PLANNING, ZONING, & BUILDING DEPARTMENT  
PZ&B Staff Memorandum: Landmarks Preservation Commission

SUBJECT: COA-23-003 (ZON-23-020) 139 N COUNTY RD—PARAMOUNT THEATER  
(COMBO)

MEETING: JULY 19, 2023

**COA-23-003 (ZON-23-020) 139 N COUNTY RD—THE PARAMOUNT THEATER (COMBO)**. The applicant, WEG Paramount LLC, has filed an application requesting a Certificate of Appropriateness for the review and approval of the renovation and adaptive re-use of an existing Landmarked theater structure, and the construction of a new three-story mixed use (retail and four residential units) development with two subterranean parking levels to replace an existing surface parking lot, including multiple variances including setbacks, height, open space, among others. Additionally, a variance to permit residential uses on the first level in the C-TS zoning district in lieu of the above the first-floor requirement has been added since originally advertised. This is a combination project that shall also be reviewed by Town Council as it pertains to zoning relief/approval.

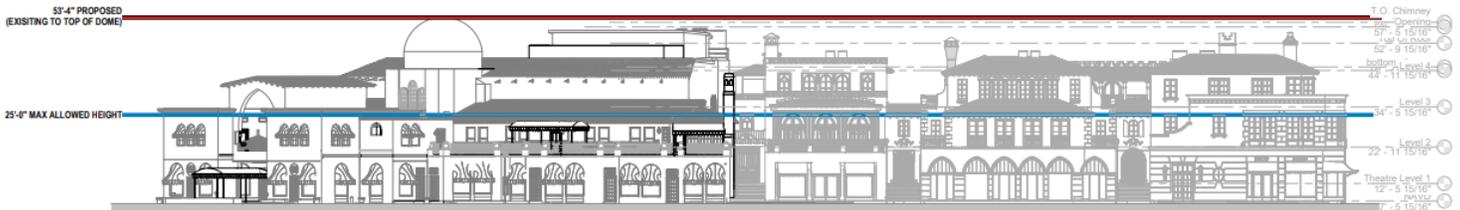
The applicant is proposing a two-level subterranean parking garage accommodating 128 parked vehicles (in a myriad of non-traditional parking methods) accessed off Sunrise Avenue. The actual parked amount proposed with 128 spaces minus 68 spaces minus 14 spaces = resulting in a surplus of 46 parking spaces. The proposal lists 128 spaces housed in the underground parking levels that will be utilized to meet the parking demand for the existing Paramount Building uses and retail uses. The new construction for the proposed four (4) new homes eight will have (8) of the parking spaces will be solely used by the owners in private garages on the sunken motor court area, and two additional spaces will be used only by the homeowners' guests.

While the applicant is not deficient in provided parking space, and in fact, has surplus parking, it is imperative to note that the proposed garage structure requires three (3) setback variances (**Variations 12, 13, 14**), the use of three non-traditional parking methods in the form of tandem, triple stacked, and mechanical lifts (**Variance 15**), a reduction in the two-way drive aisle width (**Variance 17**) and an increase in the maximum slope of the parking decks and ramps (**Variance 18**). Staff has expressed serious concerns of the possible ramifications of the underground parking garage edifice as it pertains to vehicle and pedestrian safety. Staff recommends a redesign of the parking structure to reduce the variance requests.

VARIANCE DIAGRAM - BUILDING HEIGHT DIAGRAM  
1/16" = 1'-0"

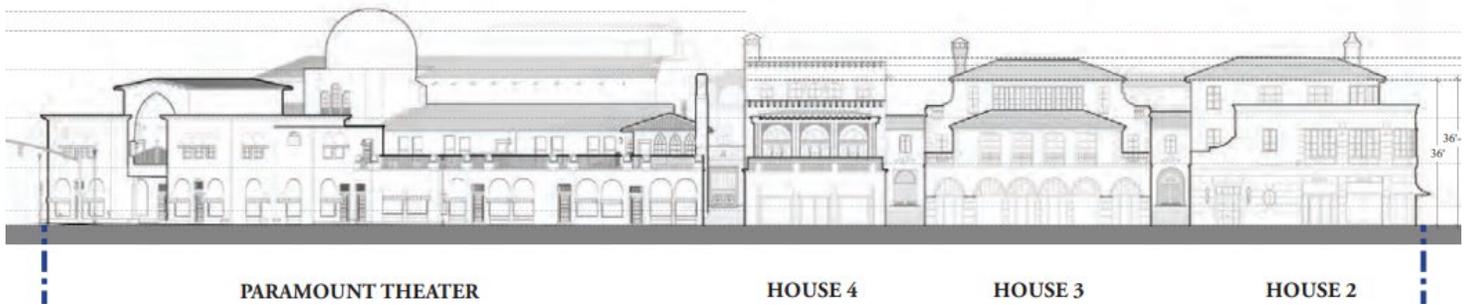
That said, when viewing the context of the proposal in relation to the landmarked three-story building and more importantly the two-story liner component of the theater, there are considerable opportunities to lower the heights of the new residences to be more in scale with its immediate context - i.e., the two-story commercial liner of the Paramount.

As proposed, the second floor of the new residences still contain a capacious 12'-6" floor to ceiling height which is inappropriate for the surrounding context. Currently, the proposed new construction will be taller than the vaulted expanse of the auditorium of the theater yet below only the signature dome of the landmarked building. The applicant has lowered the heights of the new residences in the following capacities:

- The height of House 1 has been reduced from 39 feet to 36.5 feet, and the overall height has been reduced from 43.5 feet to 40 feet; reductions of 2.5 feet, and 3.5 feet, respectively.
- The height of House 2 has been reduced from 38.5 feet to 36.5 feet, and the overall height has been reduced from 45.5 feet to 42 feet; reductions of 2 feet, and 3.5 feet, respectively.
- The height of House 3 has been reduced from 39 feet to 36 feet, and the overall height has been reduced from 44.5 feet to 41.5 feet; a reduction of 3 feet for both measurements.
- The height of House 4 has been reduced from 39 feet to 36.5 feet, and the overall height has been reduced from 43.5 feet to 41 feet, a reduction of 2.5 feet for both measurements.
